TOWN OF HARRISBURG, NORTH CAROLINA
HARRISBURG TOWN HALL
PLANNING AND ZONING BOARD MEETING

A. H-2023-04-R Tramore II: A request to annex and rezone a 25.2 acre parcel for the purpose of developing a 23-lot single-family residential development.

Staff Report – Planning and Zoning Board
Rezoning H-2023-04-(R)

DATE:	August 9, 2024
SUBJECT:	**Continued** - H-2023-04-R-Tramore II Subdivision Map Amendment Request to rezone approximately 25 acres from Cabarrus County CR to CZ- RL (Residential Low Conditional District) for the purpose of developing a 23-lot residential neighborhood.
LOCATION	9664 Hickory Ridge Rd (PIN# 5516-41-5119)
APPLICANT:	Taylor Morrison - Represented by Alan Kerley
PROPERTY OWNER:	Hickory Ridge Holdings, LLC
Staff Report Prepared by:	Shelley DeHart, Assistant Planning Director
Neighborhood Meeting:	February 15, 2024
Existing Land Use:	Vacant
Existing Zoning:	Countryside Residential – Cabarrus County
Proposed Zoning:	Residential Low Conditional District – Harrisburg

TOWN CONNECTOR STREET

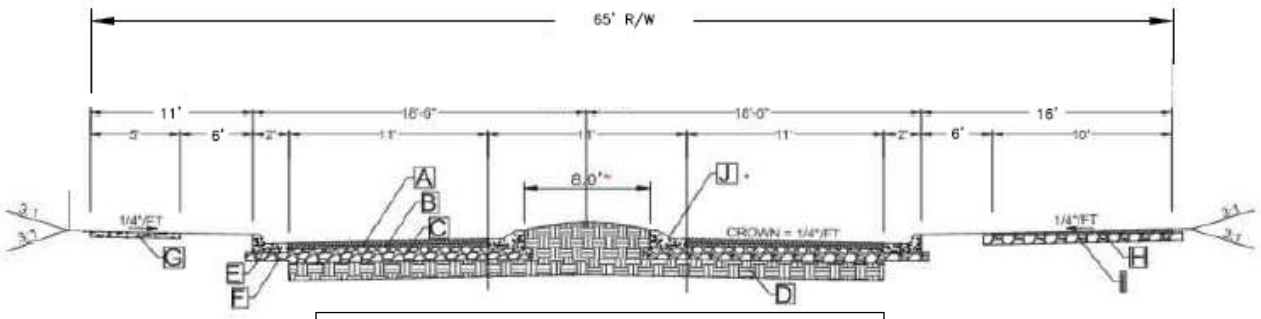
BACKGROUND: The Planning & Zoning Board considered the subject project at its July 16, 2024, public meeting. After presentation, public comment, and deliberations, the Board continued the item to the August meeting, requesting the following modifications:

ROADWAY CROSS-SECTIONS: The Board requested staff work with the development team to increase the landscape area for street trees targeting six to eight feet in width. Working together, the cross-sections have been modified to provide a minimum of a six-foot wide landscape strip for all roadway cross-sections.

a) Alternate pavement schedule is not allowable.
    b) Roadways cross sections shall be consistent with the street details within the conditional zoning plan and shall provide a minimum of a 6-foot-wide landscaped area between curb and sidewalk/multi-use path to accommodate required street trees.

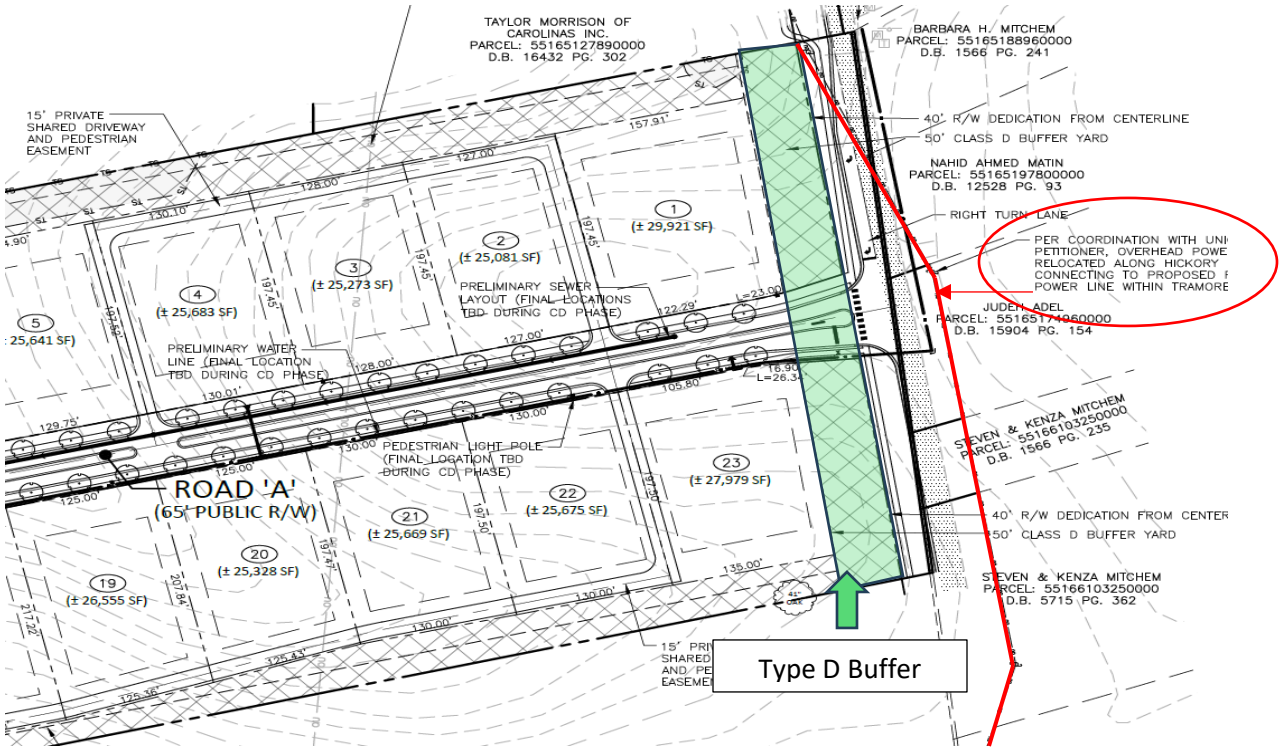
BUFFERS AND UTILITIES: The Board requested staff modify their conditions of approval to enhance protections within the required **enhanced buffers**. These buffers include the 50-foot-wide Type D landscape buffer located adjacent to Hickory Ridge Road; and the 20-foot-wide Type C landscape buffer located on the south property line behind lots 16-23.

RELOCATION OF UTILITIES: Based on correspondence from Union Power Cooperative, their plan and preference are to relocate utility lines out and along Hickory Ridge Road as reflected on the conditional zoning plan below.

c) **Condition #6 is proposed to be modified related to maintained vegetation. This proposed modification is to ensure compliance with the Unified Development Ordinance and protection of the critical root zones for trees proposed to be maintained to achieve required buffer:**

A minimum of a type A buffer is required around the perimeter of the development. ~~A field *inspection and/or detailed tree/shrub survey will be required (of combination thereof) for existing landscaping that is proposed to be retained towards required buffers.~~* ***Existing vegetation proposed to be maintained to achieve required buffers shall be identified and inventoried within the required landscape plan in compliance with Section 141.04.03 of the UDO.*** *This survey shall include the species, size, and health of all landscaping proposed to be preserved. Enhanced buffers are required as follows:*
